November 21, 2024

Response to Comments

Major Subdivision – Final Plan Amendment Application Canada Hill Subdivision

Attachment 3 – FEMA Map

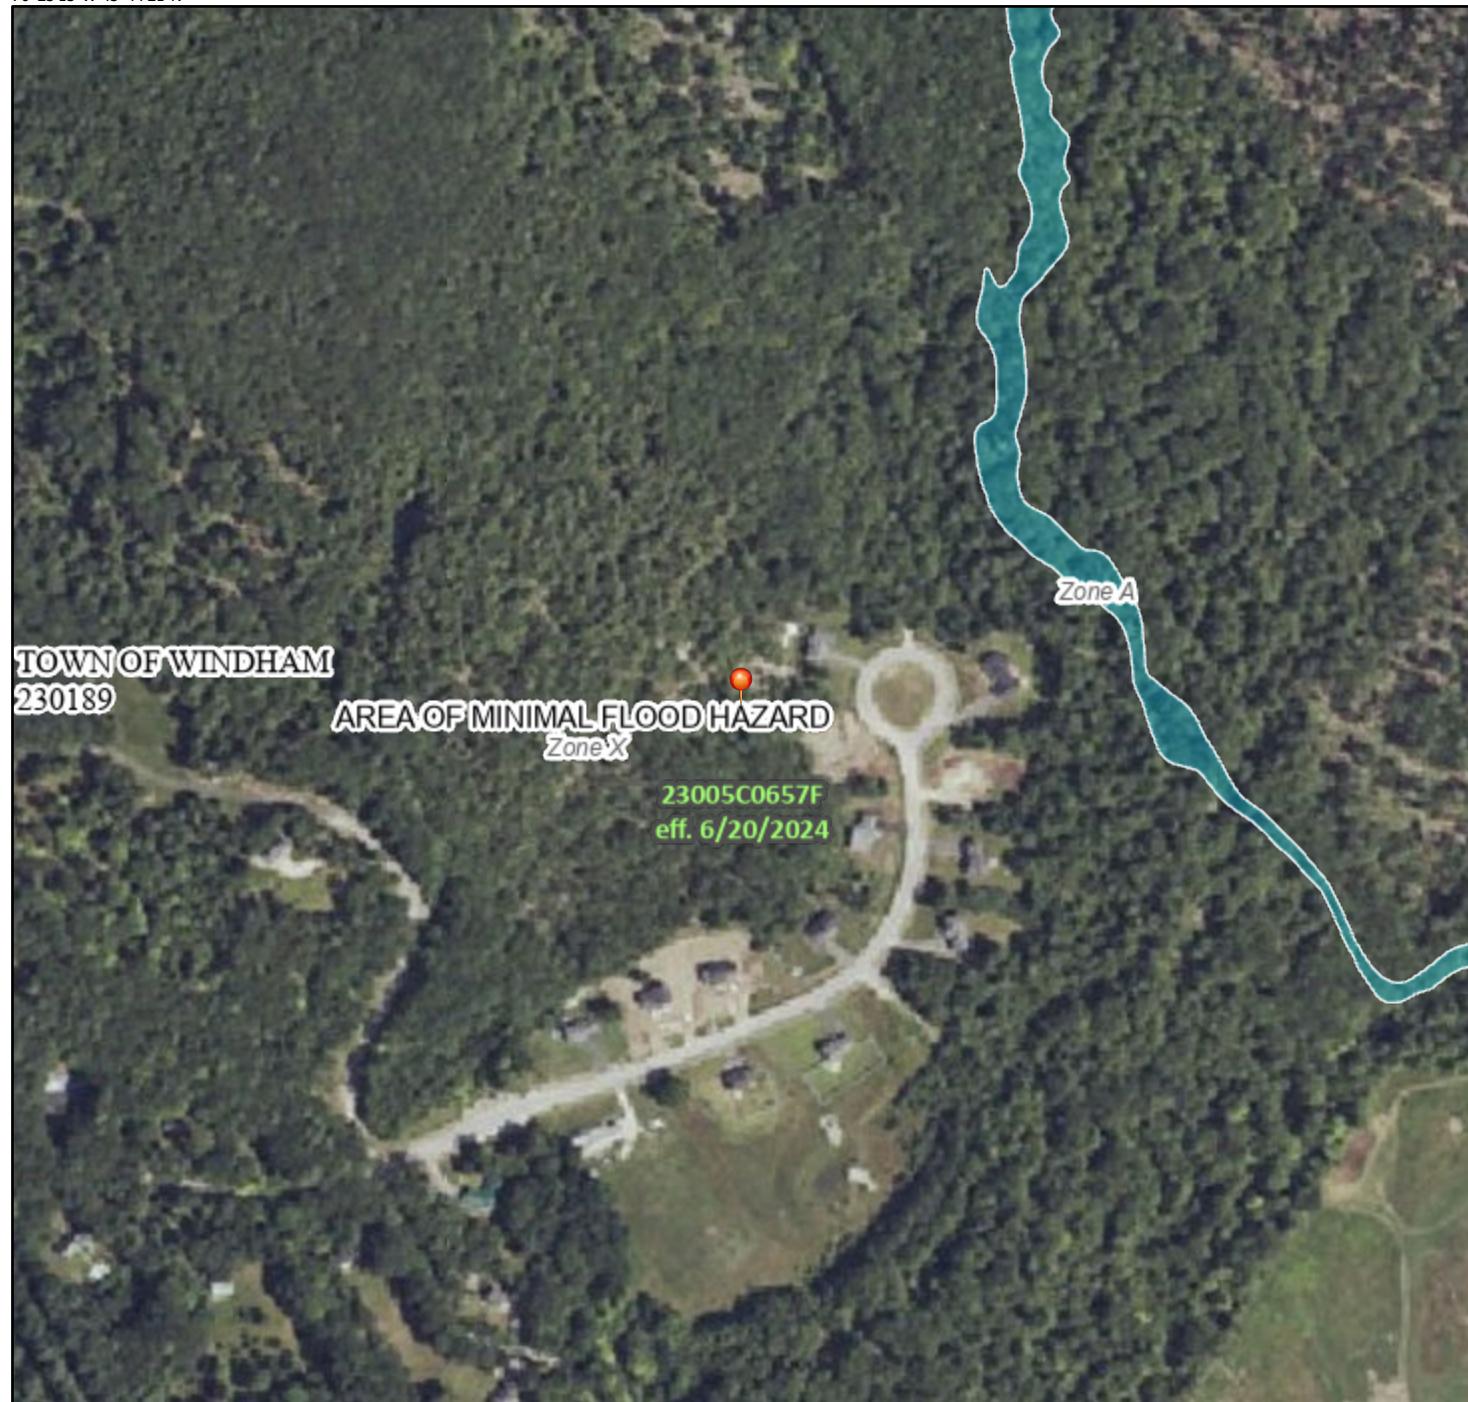
- Please update the FEMA 100yr Floodplain mapping and the net residential density calculations. The Town adopted the new map June 24, 2024.

Response: The plans have been amended to include updated FEMA 100-yr Floodplain mapping associated with Small Brook according to the Federal Insurance Rate Map 23005C0657F. See a copy of the FEMA map included in Attachment 3.

The Town Ordinance Farm District density requirements include 80,000 SF/unit of Net Residential Area. The acreage within the FEMA 100-yr Floodplain was reduced from 9.51 acres to 2.68 acres, wetlands outside the FEMA 100-yr Floodplain increased from 2.81 acres to 3.81 acres, and steep slopes increased from 6.99 acres to 8 acres. Based on the density calculations, there is a potential for 32 units versus the previously calculated 30 units within the 79.07-acre site. The full build-out of the Canada Hill Subdivision will include 27 lots.
